A G E N D A
FARRAGUT MUNICIPAL PLANNING COMMISSION

August 20, 2015
7:00 p.m. Farragut Town Hall

**SUBJECT: STAFF COMMENTS ON THE REVISED SITE PLAN FOR THE
THREE MINUTE MAGIC CAR WASH AT 11133 KINGSTON
PIKE**

**SUBJECT: STAFF COMMENTS ON THE SITE PLAN FOR THE FAÇADE
REMODEL AT THE WEST END CENTER, 129 WEST END
AVENUE**

1 FRONT ELEVATION
A200 SCALE: 3/16" = 1'-0"

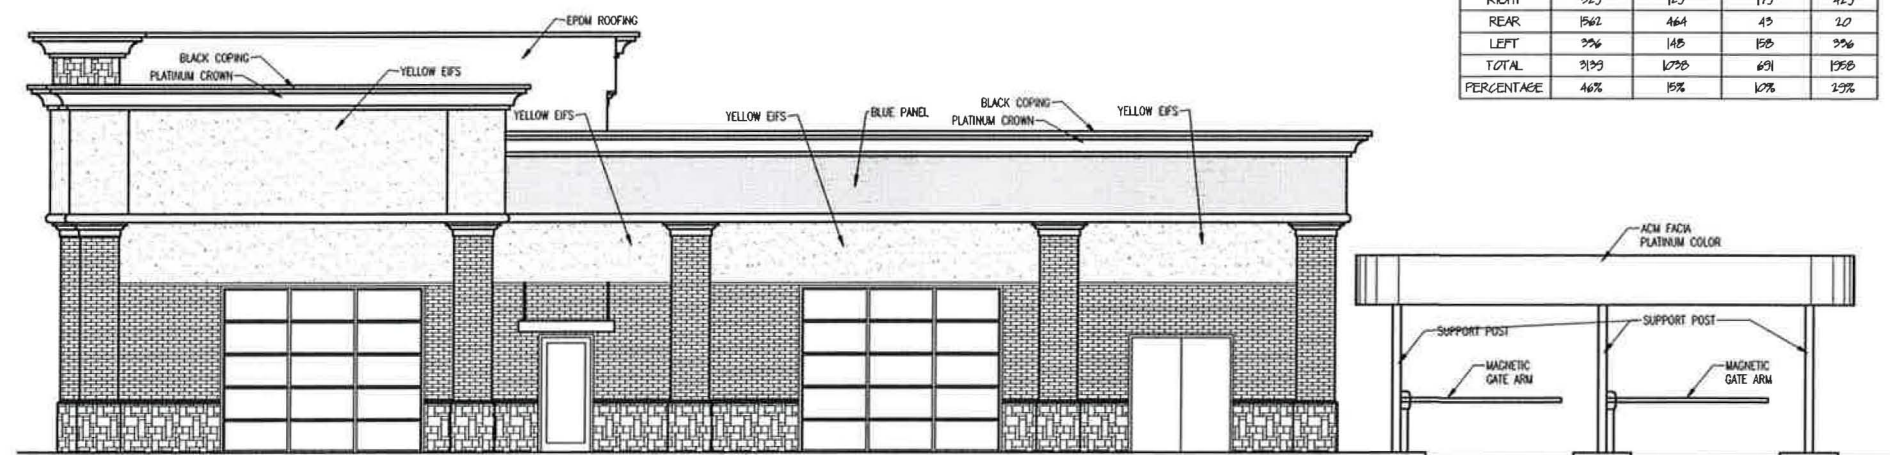
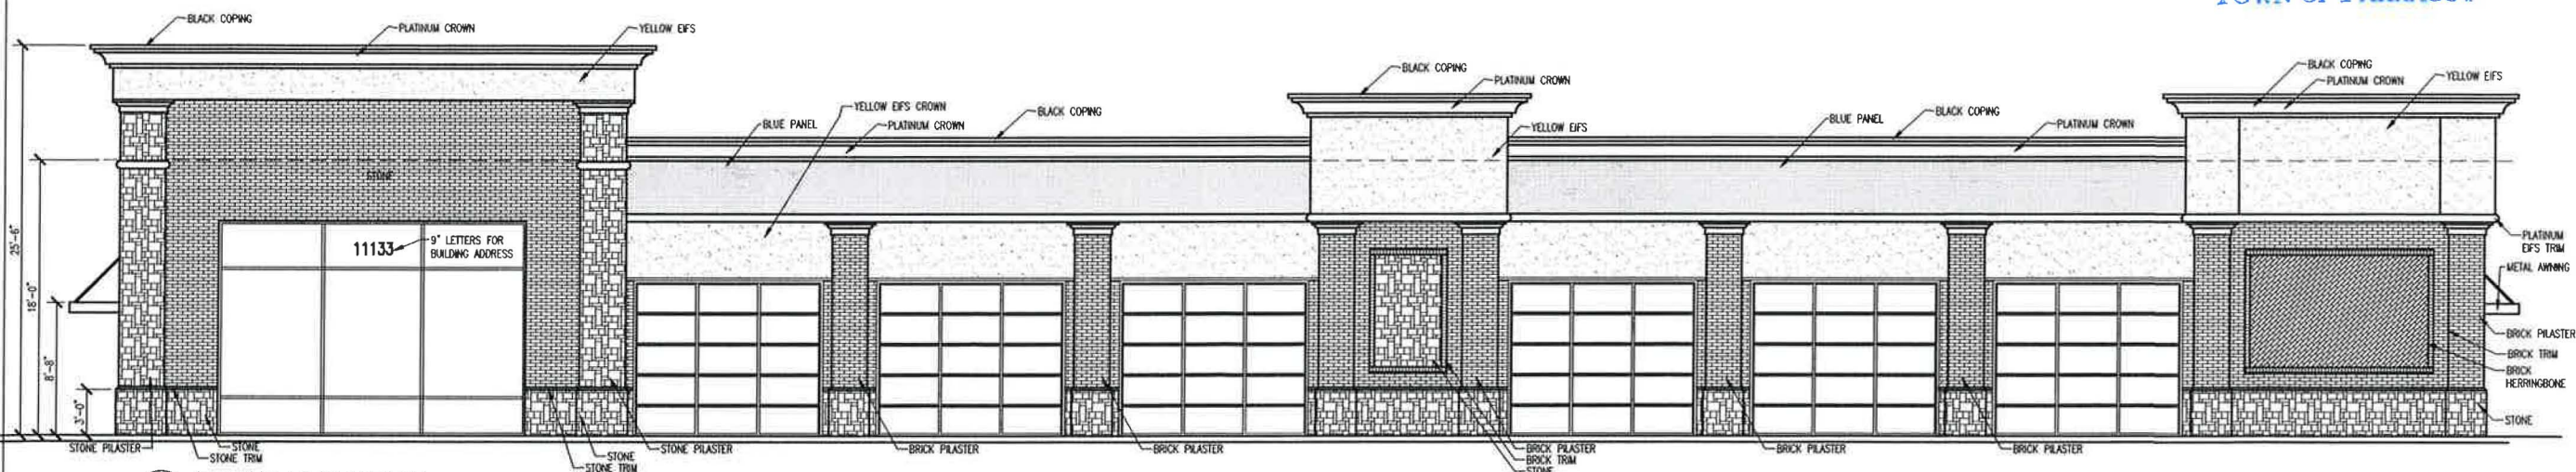
The building renderings show a blue and yellow color scheme that would not be consistent with the use of earth tones or other muted colors on a majority of the building façade and roof area. The staff will recommend that the applicant re-visit the color scheme to address this important aspect of the ADS.

- d) Per Standard 1.37, please use stormwater management systems as site amenities (see previous comment);
 - e) Per Standard 2.17, please verify that at least 60% of the net façade area is brick or stone; and

C101
Sheet 3 of 14

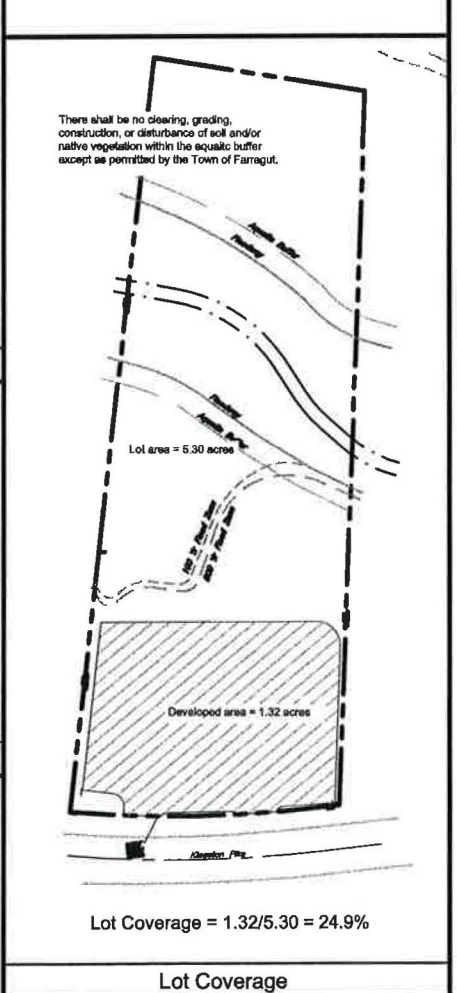
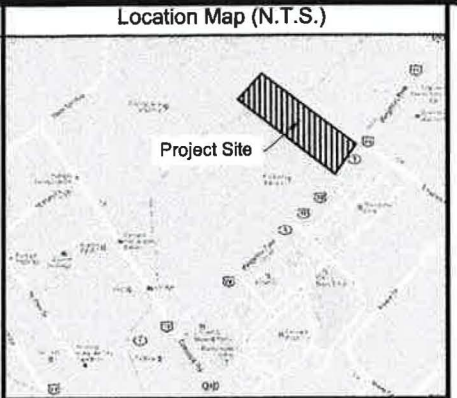
- 3) The landscaped area required between the building and parking lot on Sheet C101 is incorrect. Accessways are part of the parking lot and thus the entire building length must be factored into the required square footage. It would appear that there is roughly 450 feet of building length which would equate to 1,125 square feet of landscaped area between the building and parking lot. Please revise accordingly;

- 4) Please modify Sheet C101 to state that the dumpster pad and enclosure detail is on Sheet A300;
- 5) On Sheet C401, some of the storm sewer appears to be under the corner of the proposed building;

- 8) Please show the vacuum stations in their actual dimensions on the site layout sheet and include a visual of how they are proposed to appear as viewed from the public right of way;

COTSCO PROPANE ISLAND -- ISOMETRIC VIEW

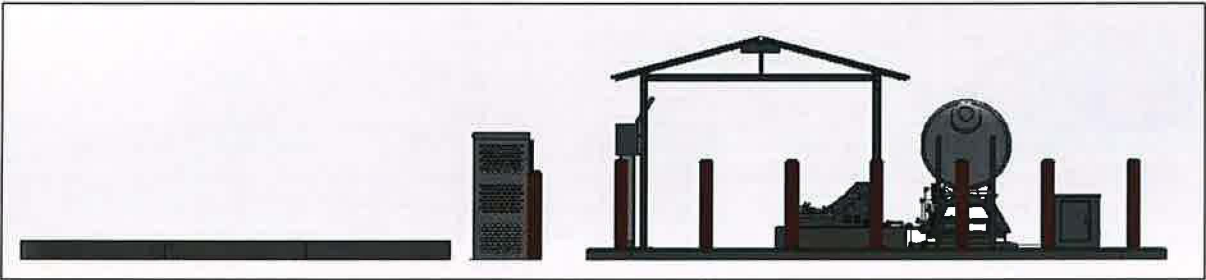
- 17) Please provide architectural details for the "pre-fabricated canopy";
- 18) Please add the map and parcel information to the site plan.
